2. Consultees' Comments on EIA Report (31/08/2025- 30/09/2025)

Comments	Reply
Ref. Cultural Heritage Act 2002 (as amended) (CAP 445). Environmental Impact Assessment (EA/ 0042/22) i.c.w. (PA 4863/22) The proposed development of a new Materials Recovery Facility (MRF). The facility is being proposed to treat source-separated and co-mingled dry recyclables collected in Malta. The proposed development will form part of the ECOHIVE Complex and will operate in conjunction with the other waste management facilities at Magħtab. Review of results identified in the Environment Impact Assessment The Superintendence has assessed the data gathered and compiled in the reports entitled <i>Coordinated Assessment, Non-Technical Summary, Architectural, Archaeological, Historical & Cultural Heritage and Related Material Assets Study for the proposed Materials Recovery Facility (MRF) and Landscape Character & Visual Assessment in Relation to an Environmental Impact Assessment (EIA) for a new Materials Recovery Facility (MRF).</i> Proposal The project involves the construction of a new Materials Recovery Facility. The facility is being proposed to treat source-separated and co-mingled dry recyclables

Figure 1: Cultural Heritage Features Within the AoI

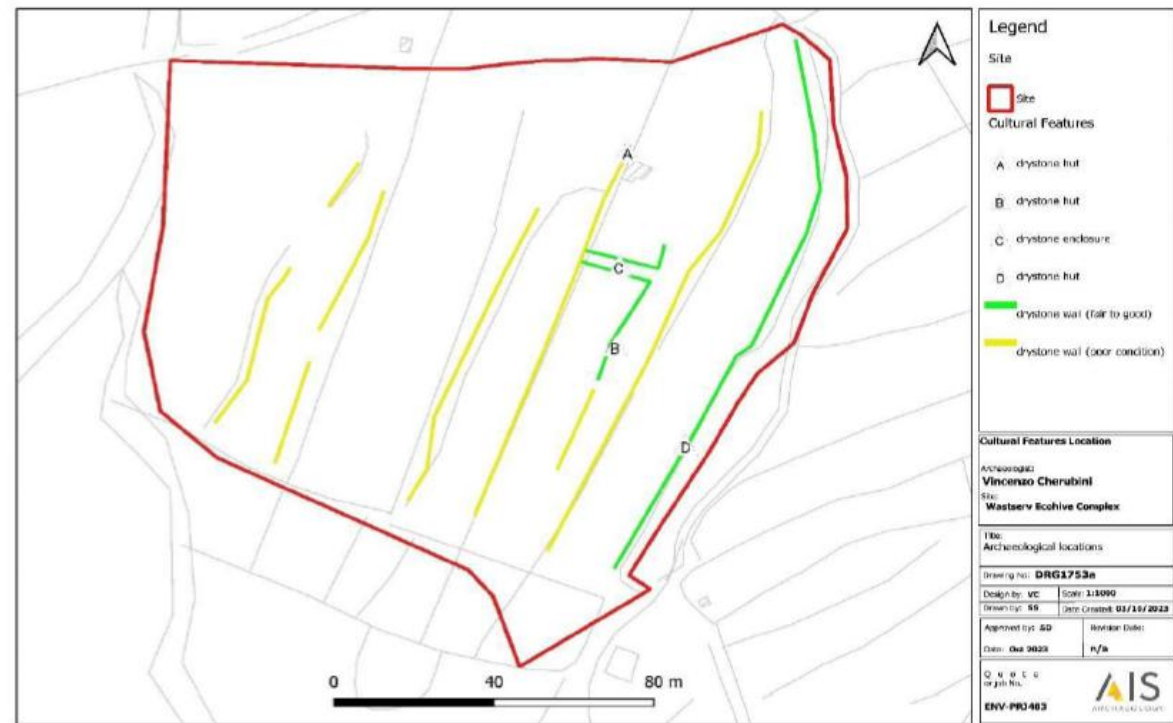
In addition to the scheduled sites referred to above, fieldwork within the AoI has also identified the presence of dry-stone huts (features A, B and D in figure 1, below), one of which has a corbelled roof (feature B).

The report notes that since the ones located within the AoI are well preserved, they should be considered a subject of architectural, cultural and ethnic value. As such it would be advisable to preserve these features by incorporating them in the landscape design or possibly relocating them to another part of the site. The Superintendence agrees with this conclusion.
